NUMBER: 80-15

DATE: 10/13/80

- A. Thermostat Deletion - Merc 7.5 and 9.8
- B. Metric Tool Requirements - Merc 18 and 25
- C. Premature Drive Shaft Spline Wear - 1979 Merc 20 (Short Shaft)

Figure 1. Top View of Drive Shaft Housing

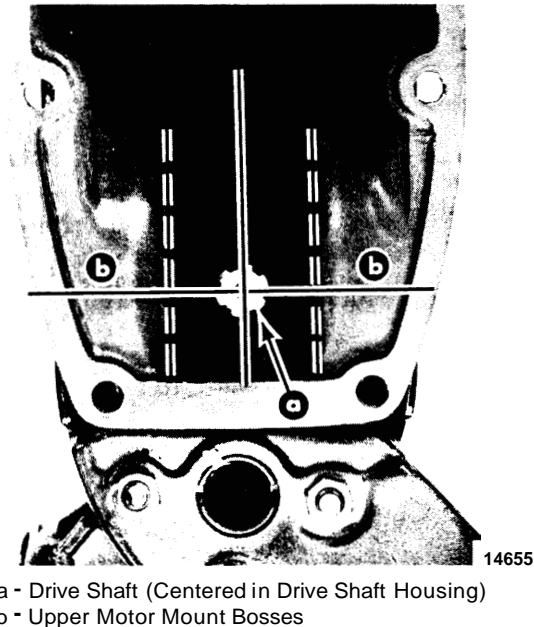
Inspection of these types of failures has revealed that the premature wear results from misalignment between the drive shaft and crankshaft, caused by improper machining on the bottom end of the drive shaft housing (A-1561-6007A2).

If this problem is encountered, the drive shaft housing alignment **MUST BE CHECKED** before installing any replacement components.

1. Remove powerhead assembly complete, bottom cowl and mounting plate assembly from lower unit.
2. Install gear housing assembly complete on drive shaft housing.
3. Viewing the drive shaft housing from **top** end, check the position of the top end of the drive shaft in relation to the drive shaft housing. (Figure 1)
4. The drive shaft **MUST BE CENTERED** laterally (port to starboard) between the drive shaft housing upper motor mount bosses, **WITHIN 1/8"** (3mm).

1. Drive shaft housing must be replaced if alignment does not check to specification (refer to "Drive Shaft Housing - Alignment Check", preceding).
2. Whenever spline wear is evident on the upper end of the drive shaft, the spline in the lower end of the crankshaft **MUST ALSO BE INSPECTED** for probable damage.
3. If both the drive shaft and crankshaft must be replaced, we recommend installation of 1980 components. The 1980 drive shaft [A-45-88094A] (short shaft) and crankshaft (A-415-7631A2) may be backfitted (as a pair, only) on Merc 20 motors, Serial No. 4403786 thru 5606491.
